MUNICIPAL CORPORATION,
KARACHI.nce No. L. C. $\frac{P.}{E.}$ 398/40.

-Plot No. 3, Ch. 9 Civil Sheet Lines. Quarter.

PLAN SHOWING PROPOSED ADDITIONS & ALTERATIONS
ON PLOT NO 3 SHEET CIVIL LINES QUARTERS

Case No. P/ 393/40-

PLAN SHOWING PROPOSED ADDITIONS & ALTERATIONS
ON DIST NO 3 SHEET CIVIL LINES QUARTERS

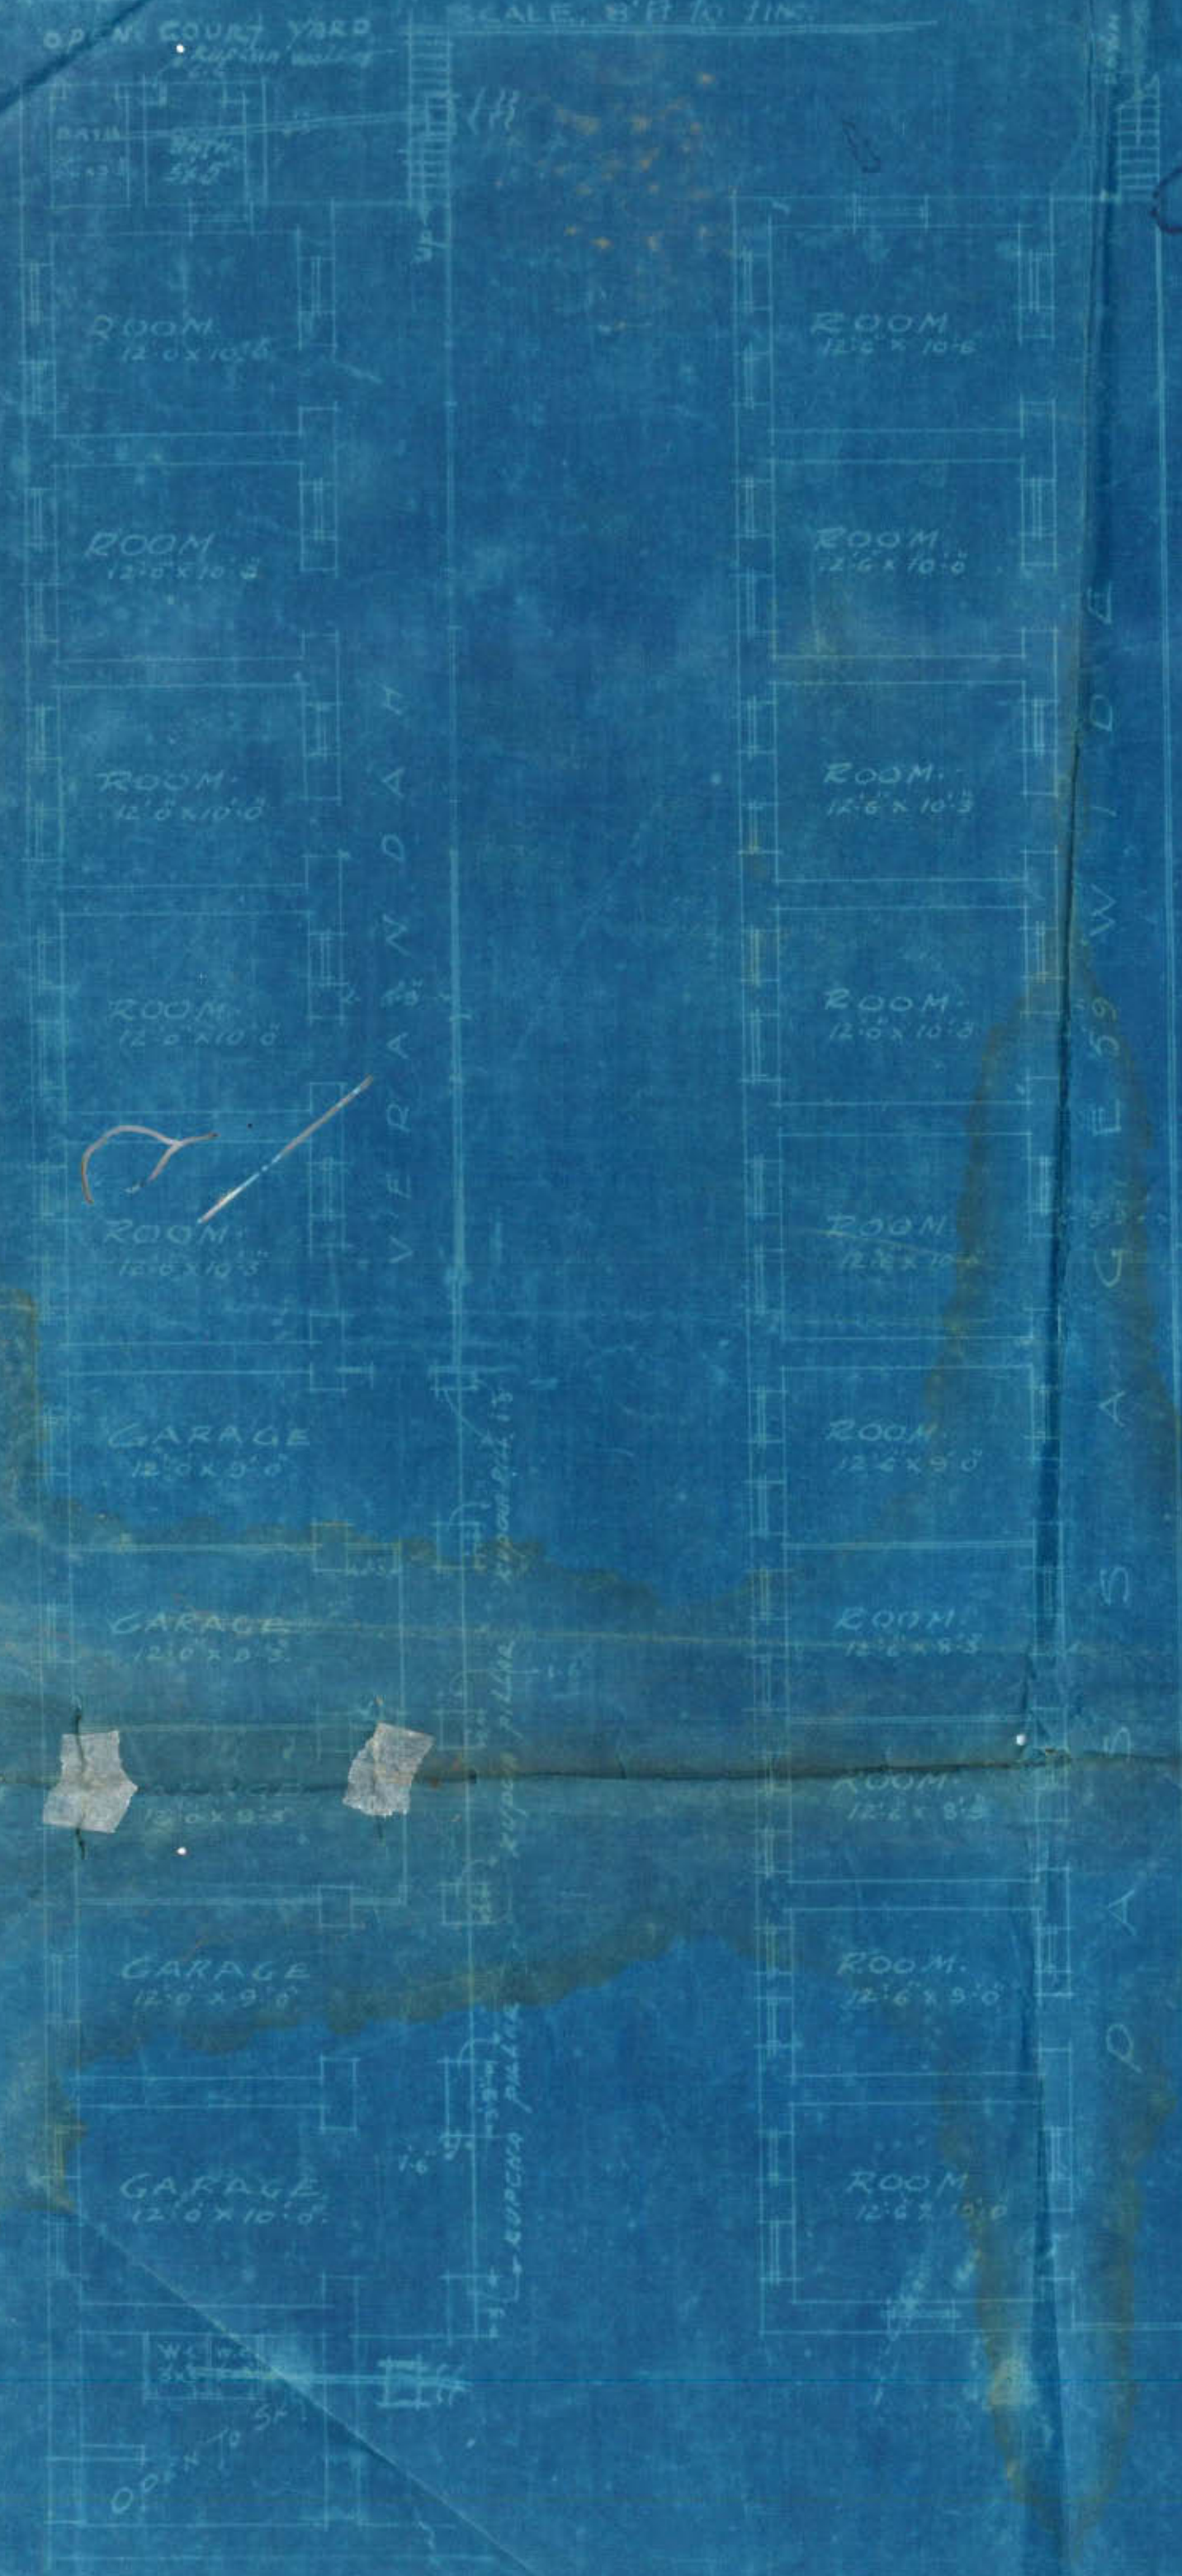
(1) Clear site plan be given.

~~Indication is in site plan~~
 Clear site plan to be given

L.S.'s Report
Report can not be made since there is
no complete site plan.

*Report can not be made since
there is no complete site plan.*

No objection to the site plan
as corrected.

The Measurements in the site plan
have now been clearly shown.
